E/ECE/324
E/ECE/TRANS/505 } Rev.1/Add.19/Rev.2/Amend.2
26 September 1995

Addendum 19: Regulation No. 20

Revision 2 – Amendment 2

UNIFORM PROVISIONS CONCERNING THE APPROVAL OF MOTOR VEHICLE HEADLAMPS EMITTING AN ASYMMETRICAL PASSING BEAM OR A DRIVING BEAM OR BOTH AND EQUIPPED WITH HALOGEN FILAMENT LAMPS (H4 LAMPS)

Figure 1

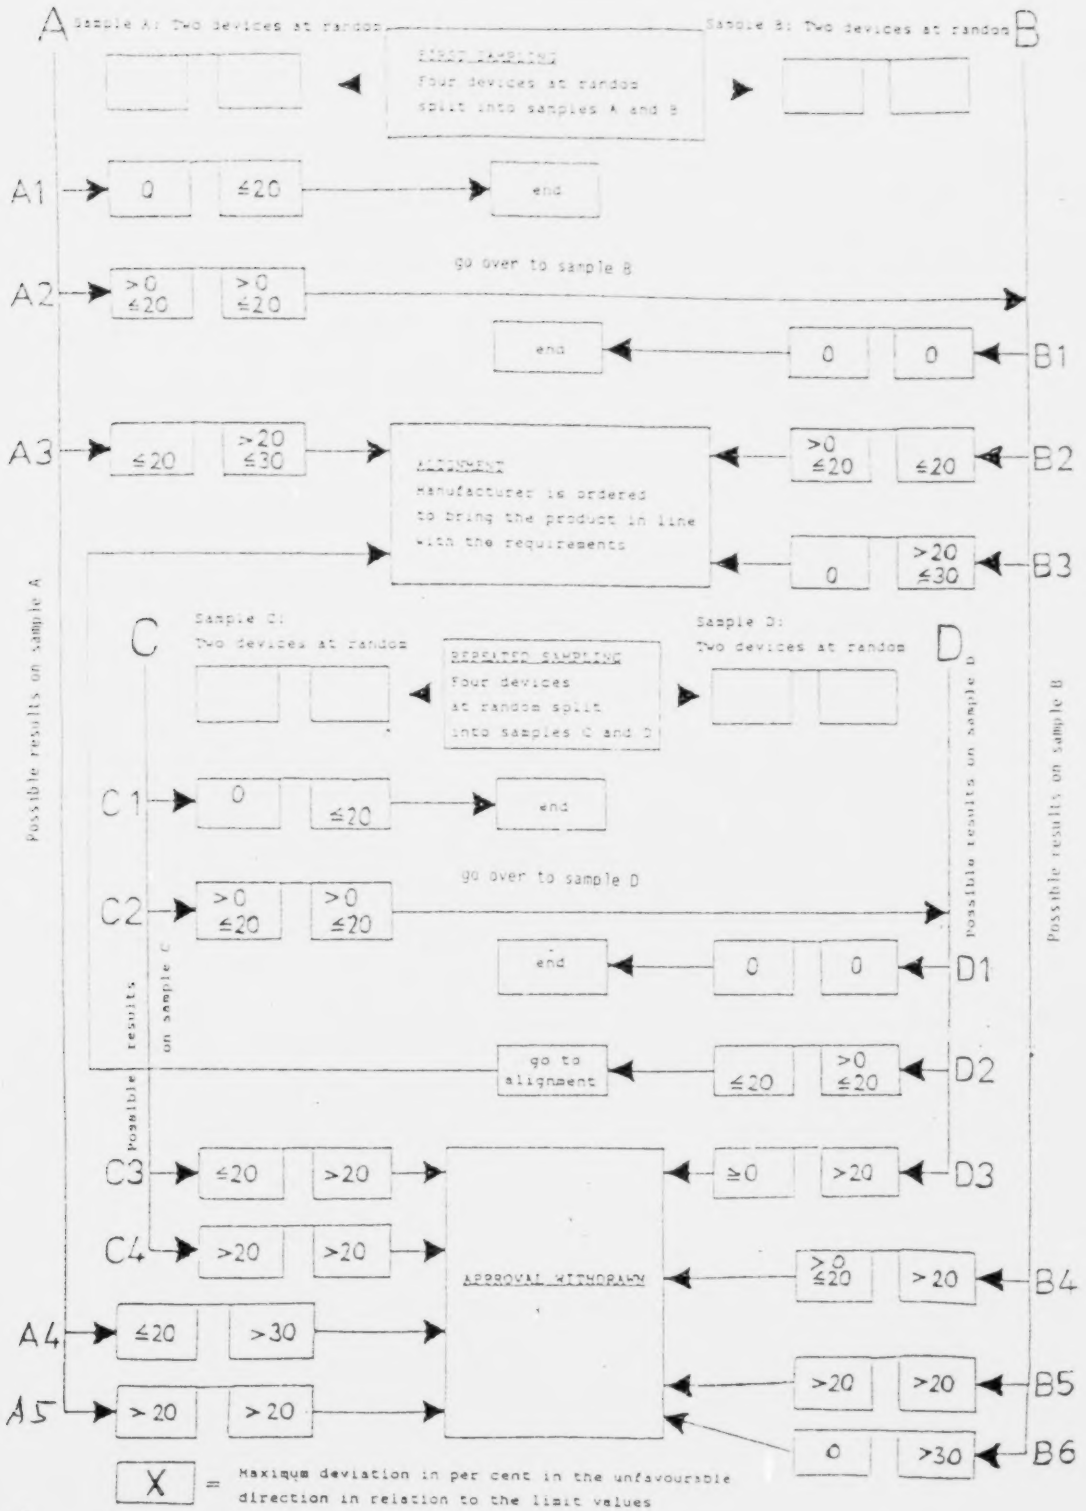
Add a new Annex 7, to read:

2. FIRST SAMPLING

2.1.1. Following the sampling procedure shown in Figure 1 of this Annex the conformity of mass-produced headlamps shall not be contested if the deviation of the measured values of the headlamps in the unfavourable directions are:

2.2.1. Following the sampling procedure shown in Figure 1 of this Annex the conformity of mass-produced headlamps shall be contested and the manufacturer requested to make his production meet the requirements (alignment) if the deviations of the measured values of the headlamps are:

Conformity shall be contested and paragraph 13 applied if, following the sampling procedure in Figure 1 of this Annex, the deviations of the measured values of the headlamps are:

In the cases of A3, B2, B3 a repeated sampling, third sample C of two headlamps and fourth sample D of two headlamps, selected from stock manufactured after alignment, is necessary within two months time after the notification.

3.1.1. Following the sampling procedure shown in Figure 1 of this Annex the conformity of mass-produced headlamps shall not be contested if the deviations of the measured values of the headlamps are:

3.2.1. Following the sampling procedure shown in Figure 1 of this Annex the conformity of mass-produced headlamps shall be contested and the manufacturer requested to make his production meet the requirements (alignment) if the deviations of the measured values of the headlamps are:

Conformity shall be contested and paragraph 14 applied if, following the sampling procedure in Figure 1 of this Annex, the deviations of the measured values of the headlamps are:
